Permit Number: 041726

This is to certify that 1039 Riverside Llc /HardyP Construction
has permission to Bldg#7/ Warehouse Distrib / w/ Small Shop & Office
AT 1039 Riverside St L 331 A001001

Memorandum

To: Bob Gaudreau
From: Mike Nugent/Manager of Inspection Services
Date: 12/08/2004
Re: Building # 7 1039 Riverside St. (331 A001)

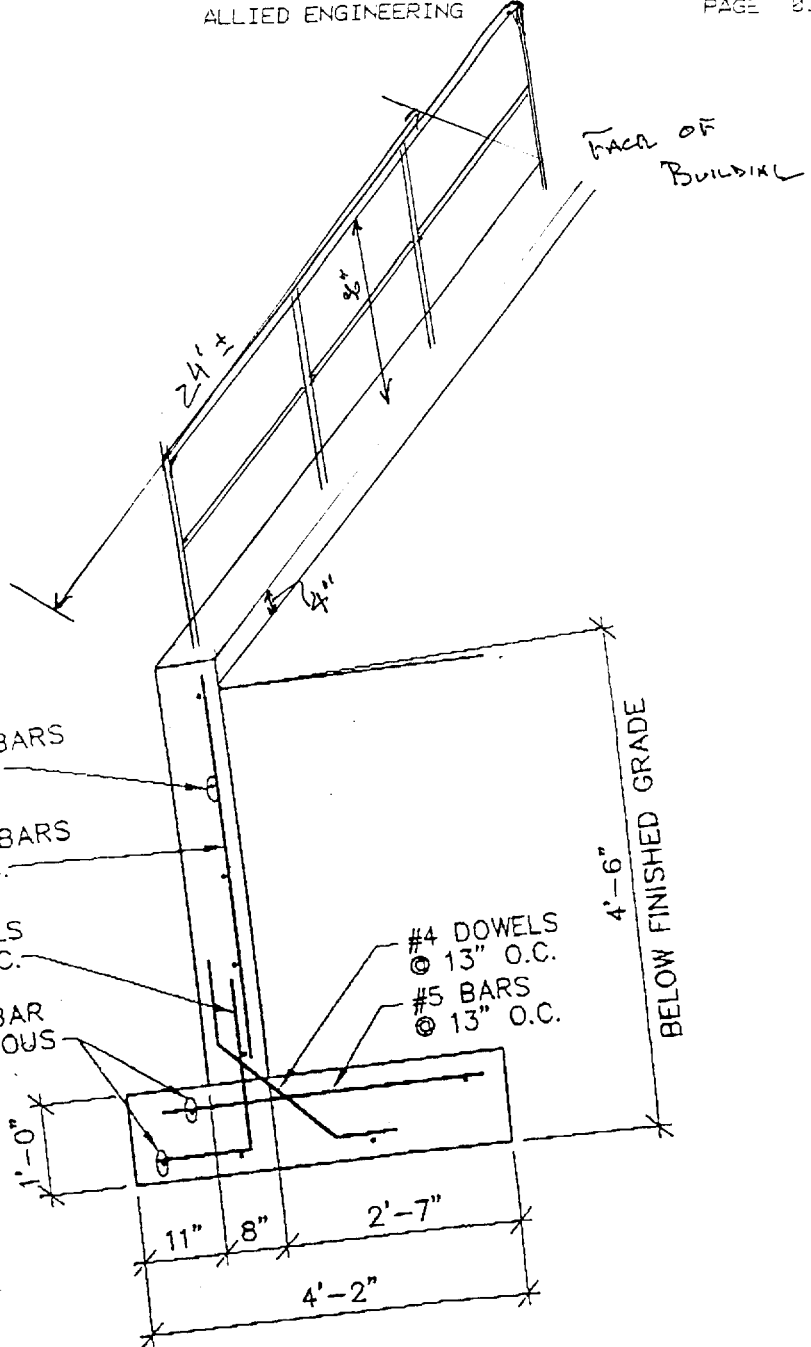
The guard for the retaining wall needs to be 42 inches with openings less than 4 inches, the plan does not reflect that.

- ALLIAD ELEC 10) Retaining wall height and specs... Guard may be required, if so guard info.
